Application for URBAN DESIGN COMMITTEE Review

IDLEWOOD AVENUE MODERN ROUNDABOUT PROJECT

Urban Design Committee recommends:

UDC No. 2014-30

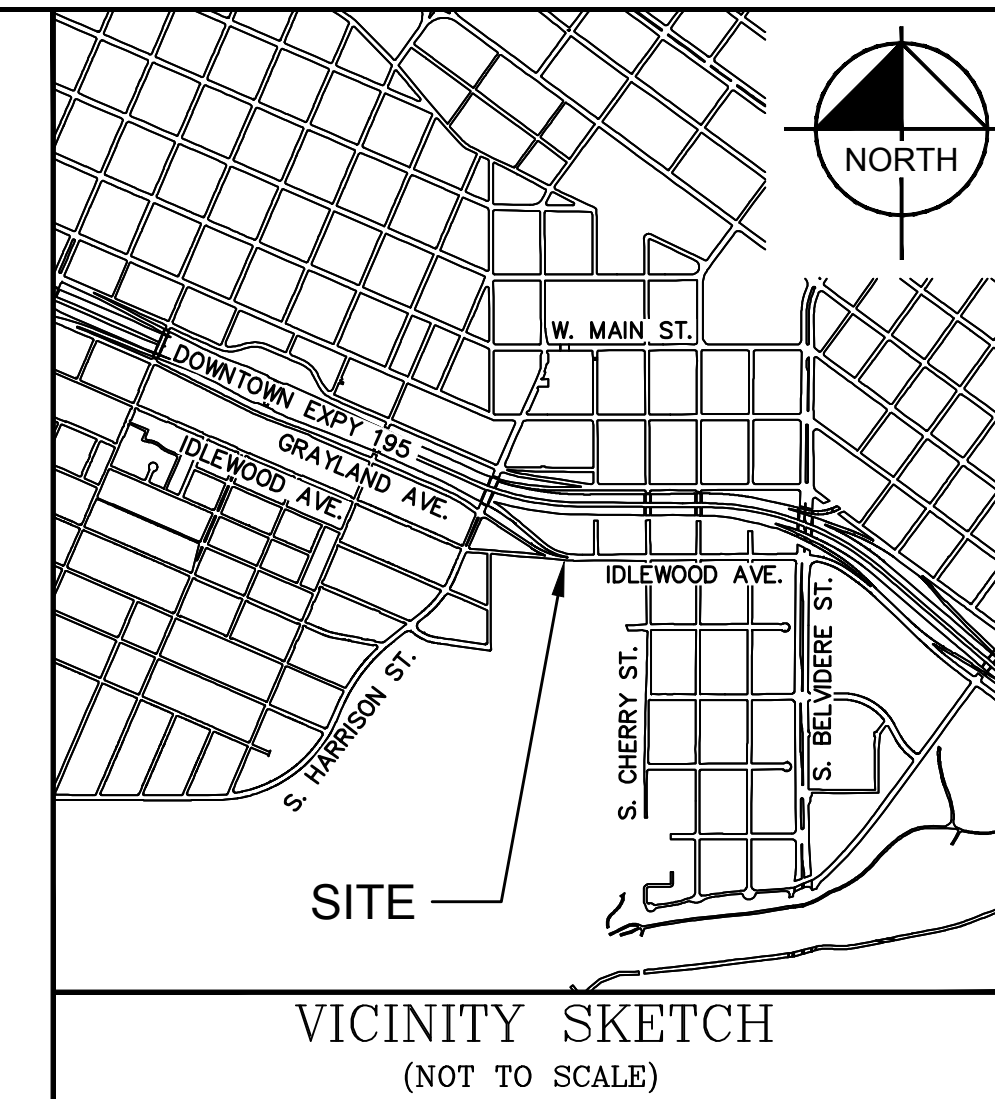
(10) That the sidewalks from S. Cherry Street to S. Harrison Street be cleaned up and re-established as part of the roundabout installation project.

Will do.

PLAN SHEET-IDLEWOOD AVE. STA. 104+00 TO STA. 108+95

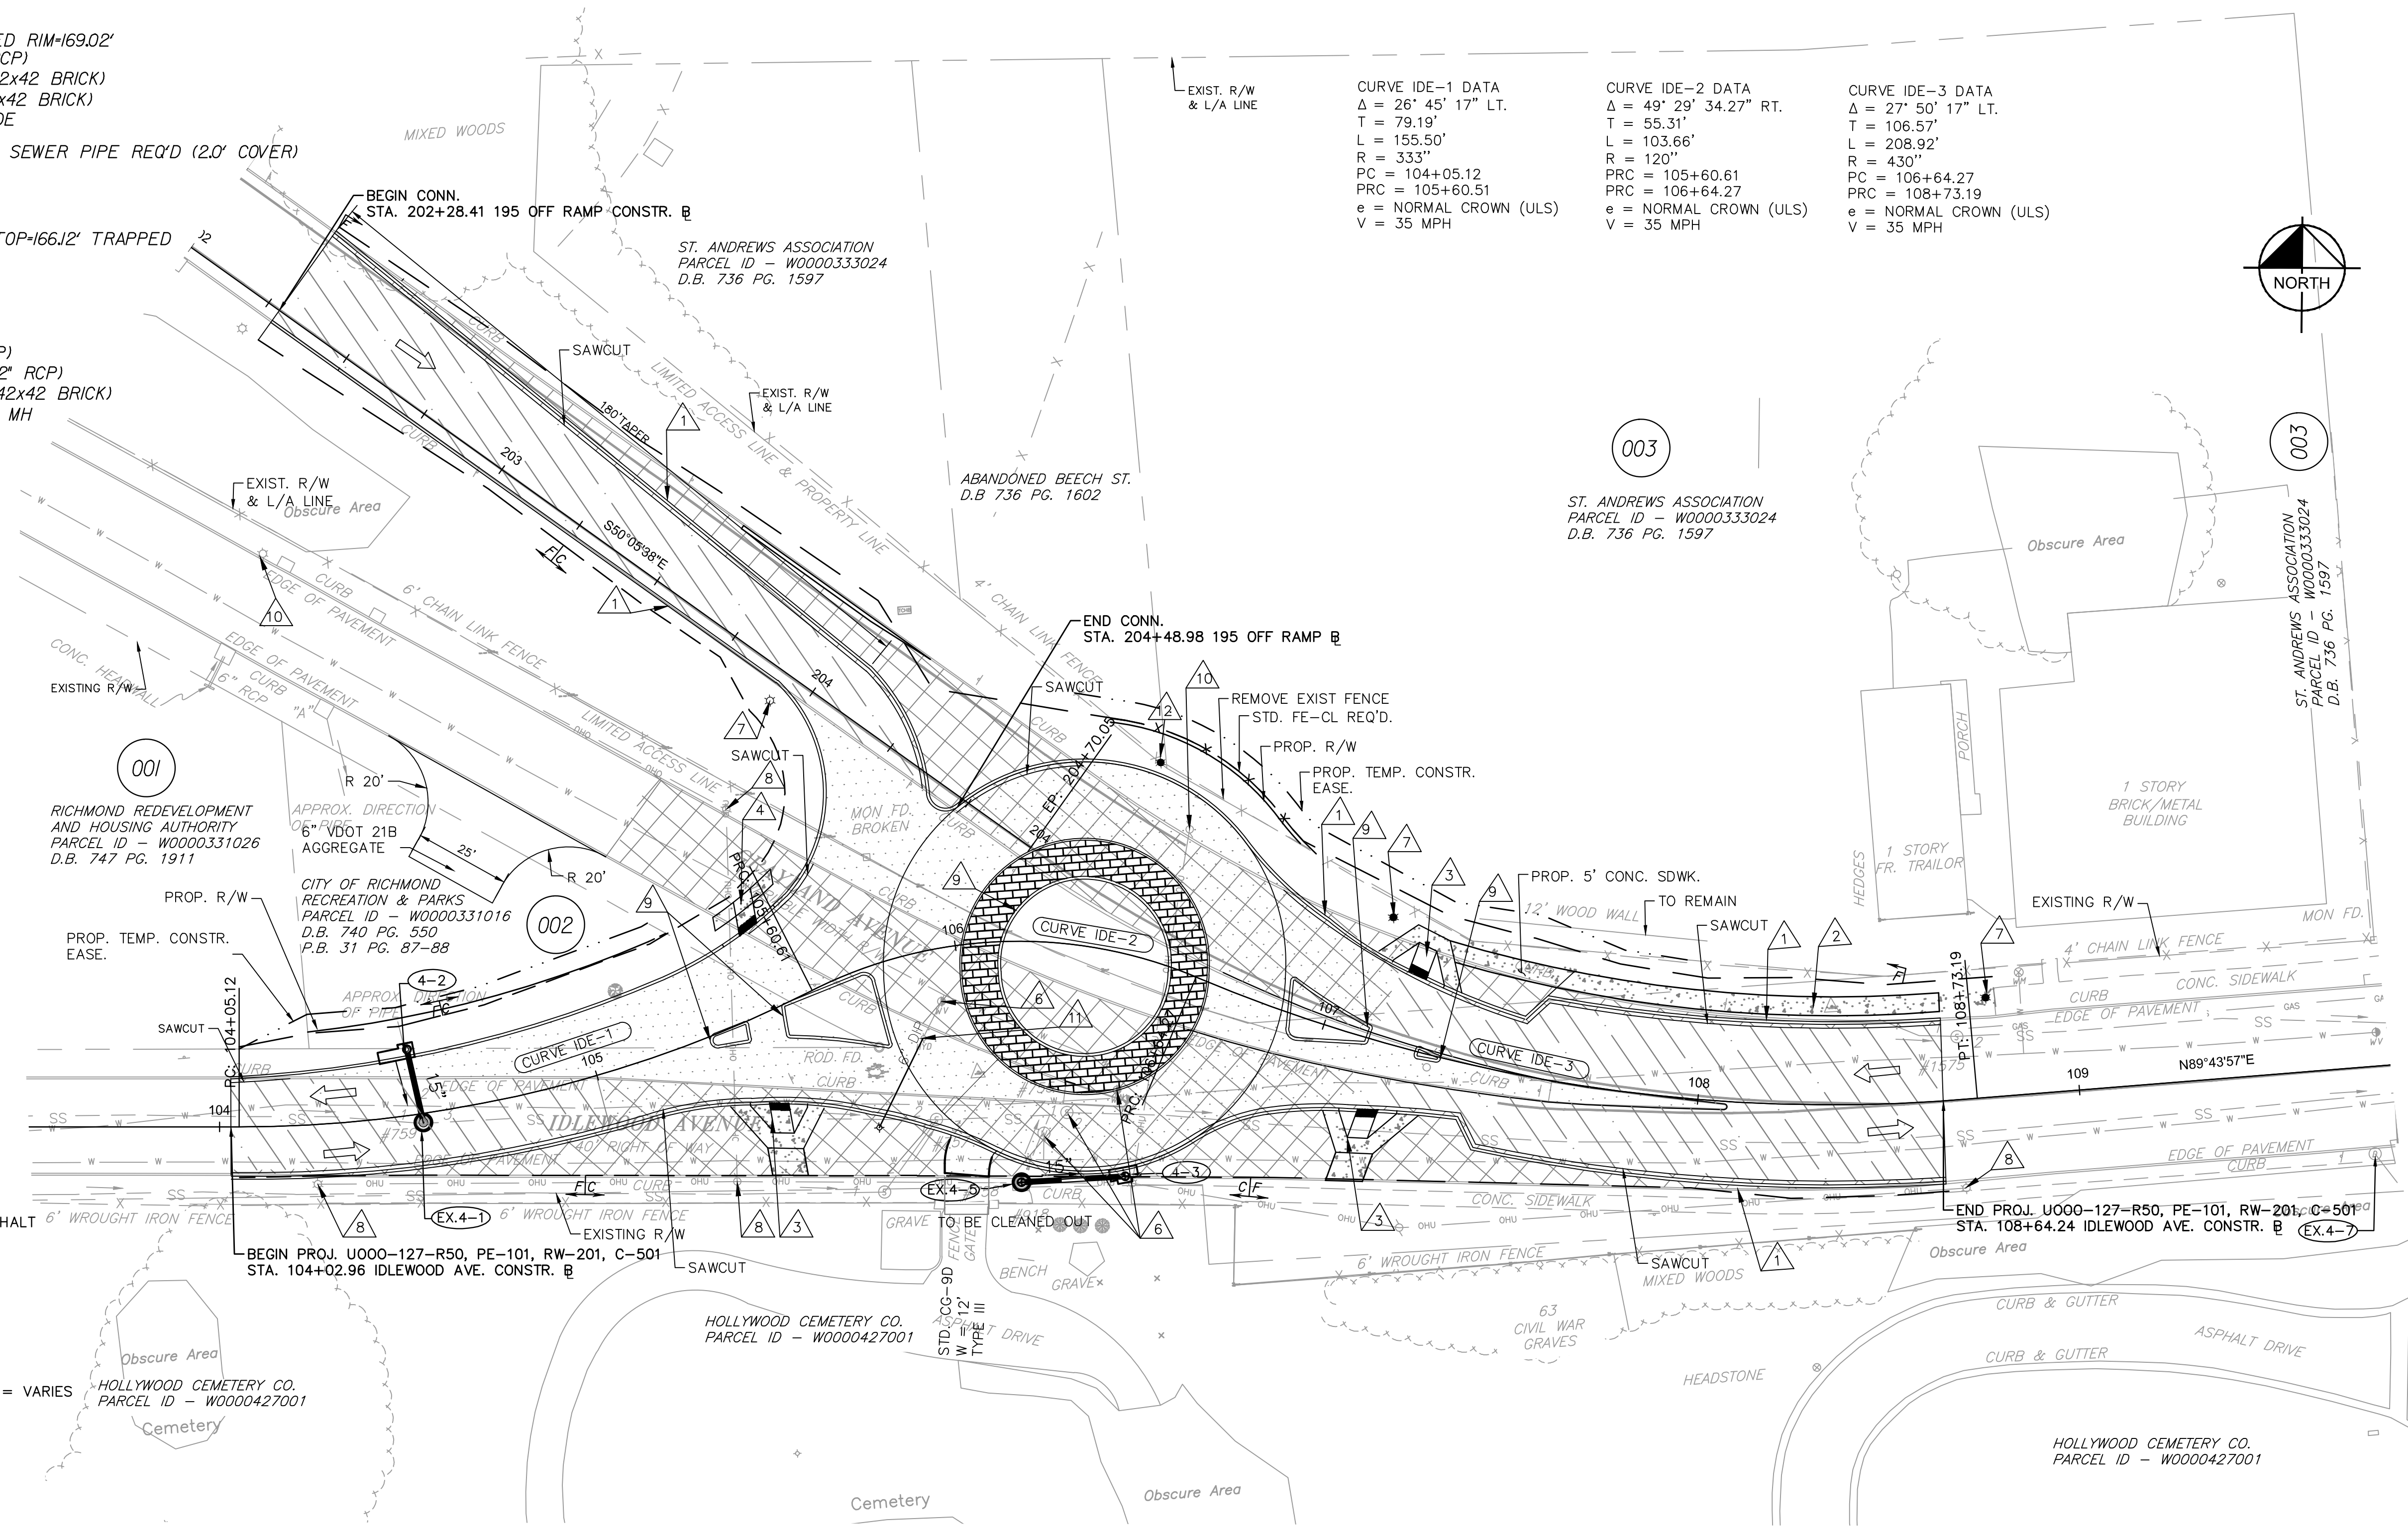
(11) That the final plans include a lighting plan.

Proposed lights to be installed by DPU are now shown on Sheet 3 identified as follows:
Incidental (triangle) # 12 – New DPU Light location
Incidental (triangle) # 10 – Existing RMA Light to be removed and not replaced
Incidental (triangle) # 7 – Existing RMA Light to be removed and replaced with DPU light
